COBEY CREEK - 1ST PLAT

STREET, STORM SEWER, LAND DISTURBANCE AND MASTER DRAINAGE PLANS

STREET AND STORM SEWER PLANS
COVER SHEET

X-REF NO. XXX
DRAWING NO. XXX
DATE March 27, 2019
JOB NO. 16.059.01
SHEET 11 OF 53

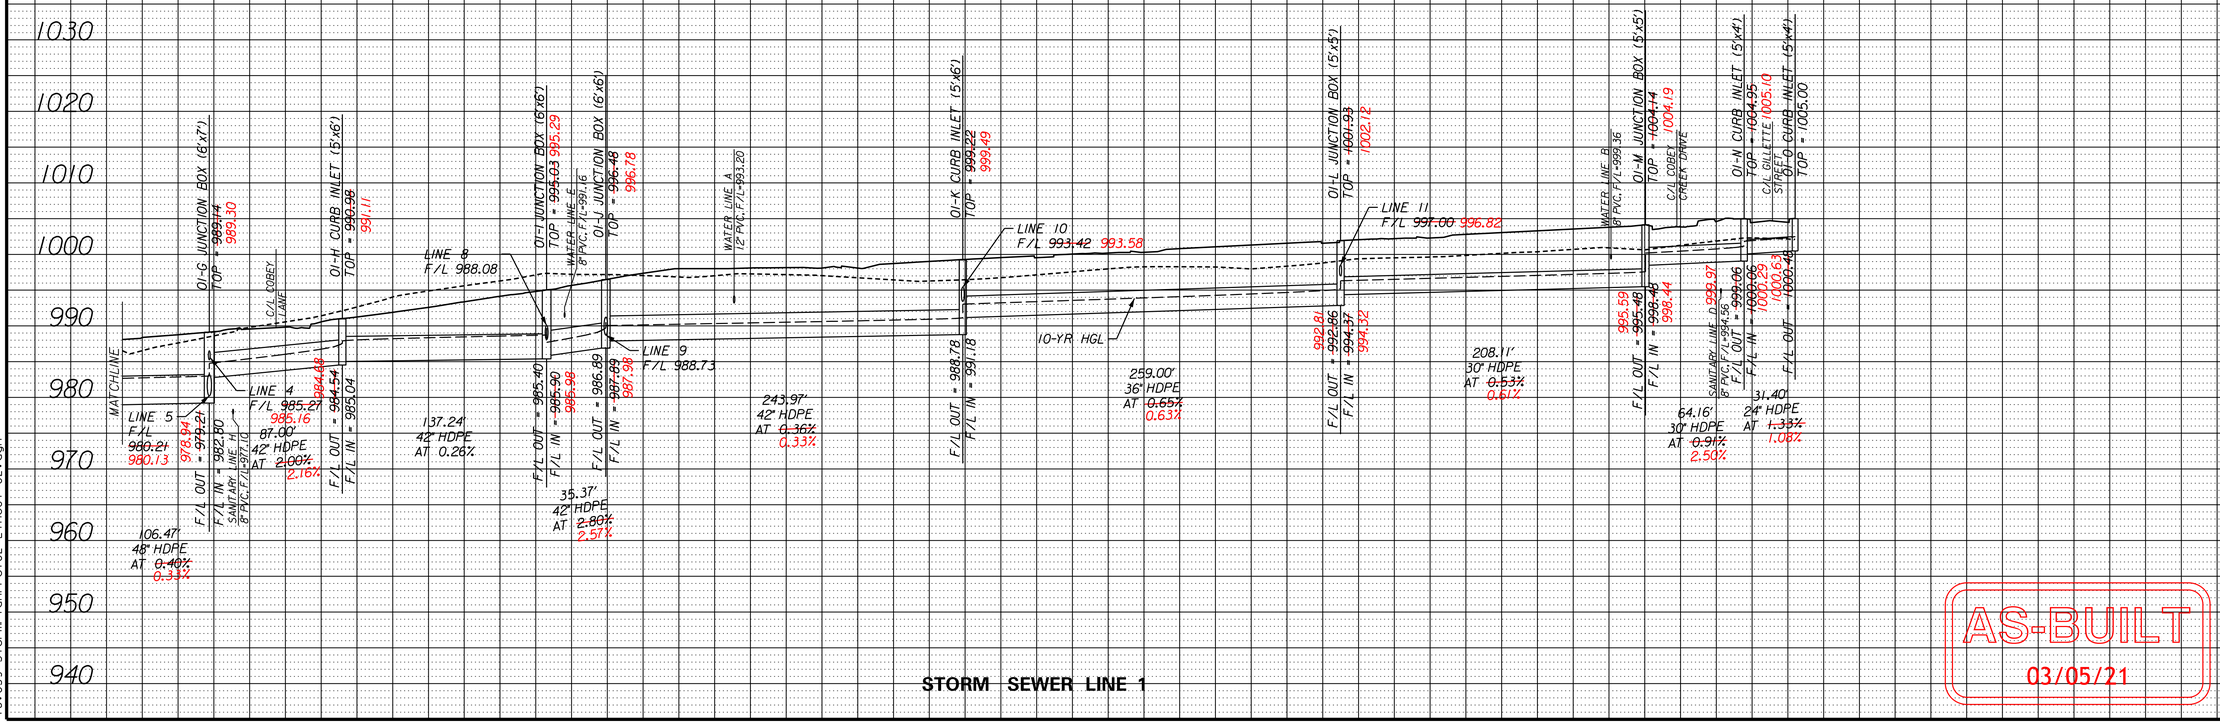
OI-L JUNCTION BOX (5'x5')
STA. 16+53.22 COBEY CREEK DR. 19.00' RT
TOP = ~~1001.93~~ 1002.12
N: 978481.70
E: 2827588.65

OI-M JUNCTION BOX (5'x5')
STA. 14+40.12 COBEY CREEK DR. 18.00' RT
TOP = ~~1004.14~~ 1004.19
N: 978268.77
E: 2827579.85

OI-N CURB INLET (5'x4')
STA. 16+68.95 GILLETTE ST. 17.50' RT
TOP = ~~1004.95~~ 1005.10
N: 978247.15
E: 2827514.51

X-REF NO. XXX
DRAWING NO. XXX
DATE March 27, 2019
JOB NO. 16.059.01
SHEET 17 OF 53

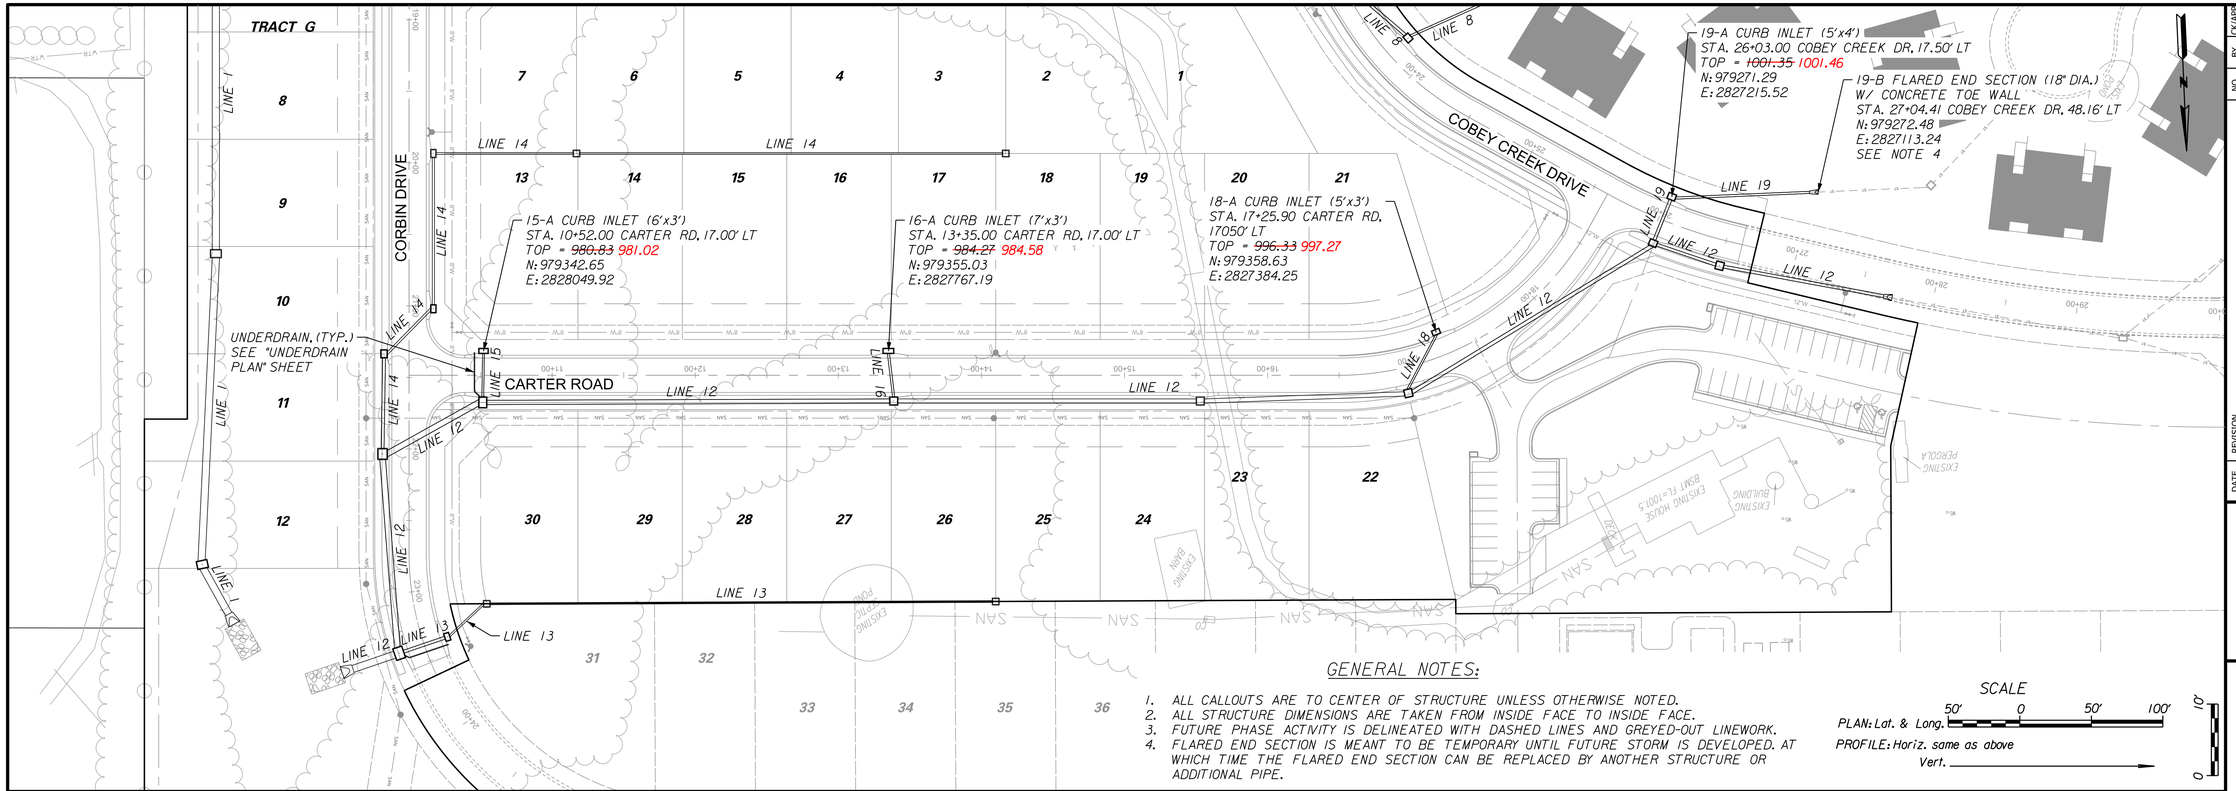
296.00'
15" HDPE
AT ~~1.80%~~ 1.88%

14-E FIELD INLET (4'x4')
TOP = ~~991.19~~ 991.29
THROAT OPENINGS = 990.19 (N,S,W)
F/L OUT = ~~985.62~~ 985.78
